Government of India - Ministry of Railways
Research Designs & Standards Organization
LUCKNOW - 226 011

MODIFICATION SHEET No. RDSO/2007/EL/MS/0349 Rev.'0' Dated 18.05.2007

Modification of providing additional isolating cock in series with existing BP angle cock in pure air brake and dual brake Electric Locomotives.

ANNEXURE- I of MODIFICATION SHEET No. RDSO/2007/EL/MS/0349 Rev.'0' Dated 18.05.2007

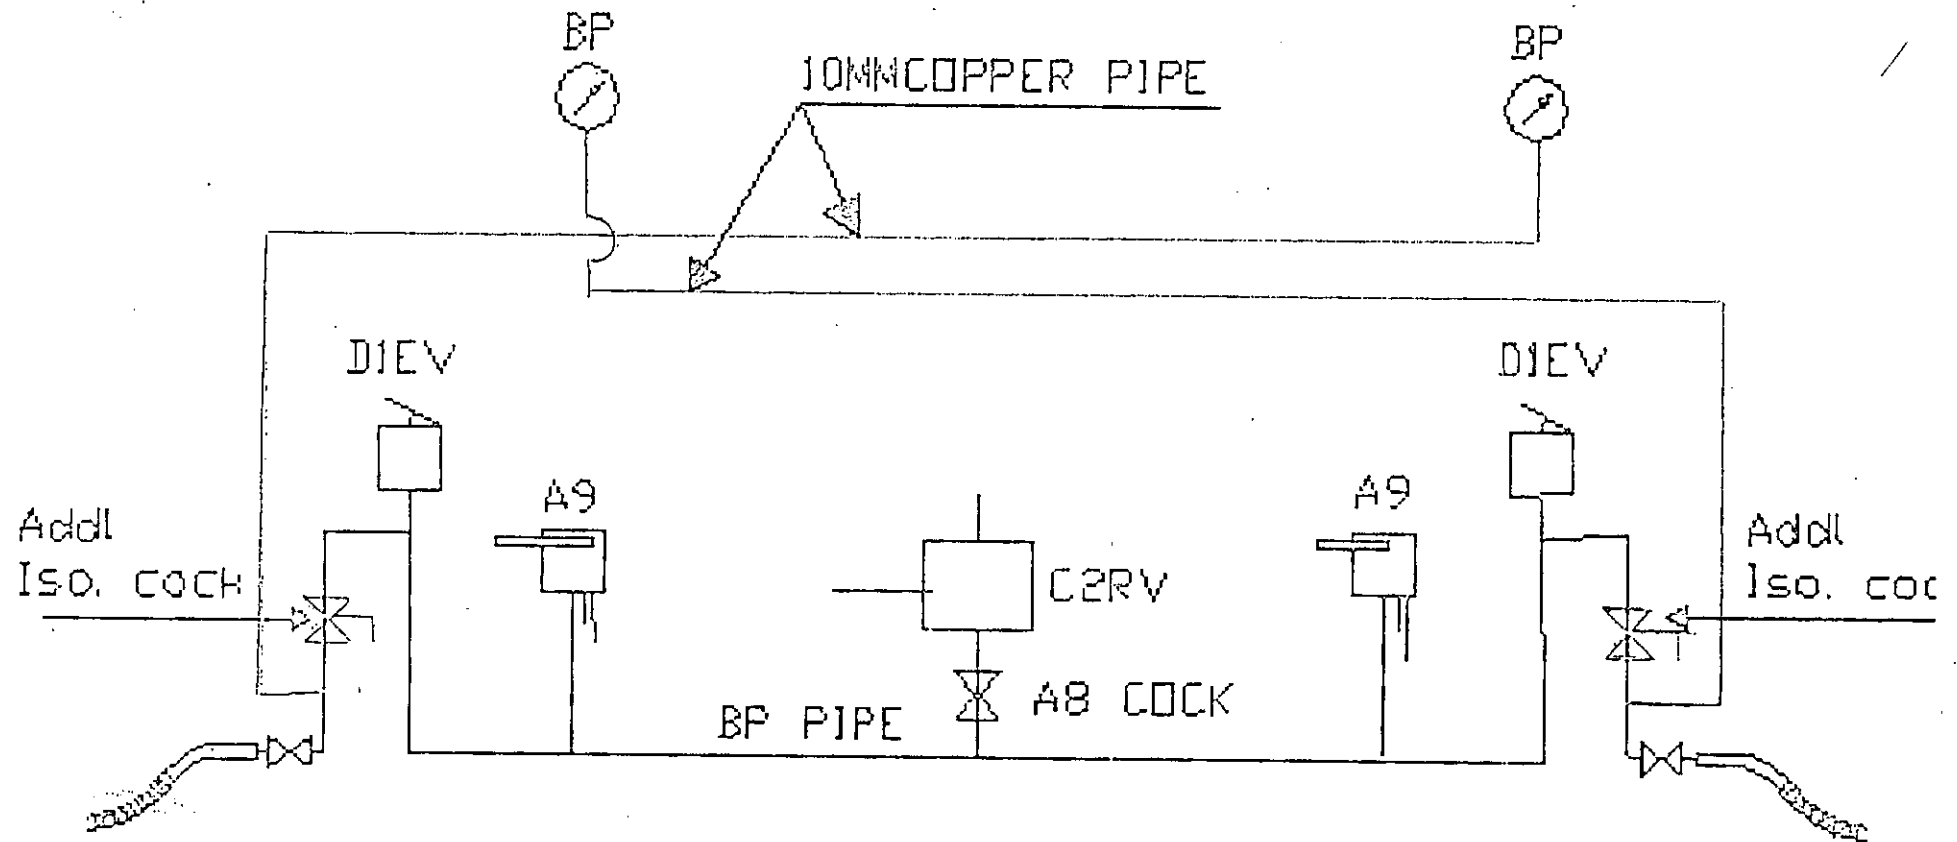
In the existing pneumatic brake system for Electric Locomotive on Brake Pipe (BP) & Feed Pipe (FP) line angle cock are provided

in front of buffer beam. There are cases of breakage of BP & FP angle cocks due to cattle run over.

Railways are reporting that failures of Electric Locomotives are taking place due to breakage of Brake Pipe and Feed Pipe angle cocks. Therefore, provision of additional Isolating cocks, behind the loco buffer beam at an approachable location, has been considered so that loco failures can be avoided by closing these isolating cocks, to prevent air leakage due to damage of existing angle cock by cattle run over.

To avoid locomotive failure due to damage of front BP angle cock during cattle run over, feasibility study was done to check possibility to provide additional isolating cocks for both Brake Pipe and Feed Pipe. Study of pipe layout on various locomotives was done and it was observed that it is feasible to provide additional Isolating Cocks on Brake Pipe at both the ends of Electric Locomotives without much difficulty.

In view of above, one additional Isolating cock of size 1¼" without vent may be provided on brake pipe only in both the driving cabs. To ensure the 'Open' position of additional BP isolating cock fitted in the non-driving cab of the locomotive, a modification in the BP gauge pipe line may be done to adopt fail-proof system. BP pressure gauge of cab-1 may be connected to the brake pipe beyond the additional BP isolating cock of cab-2 and vice-versa. With this arrangement, the BP pressure gauge of the driving cab indicates the BP pressure beyond the additional BP isolating cock of the non-driving cab. A sketch showing the above arrangement is enclosed as Annexure - II.

As per Annexure – I & II, the Brake Pipe line is to be modified.
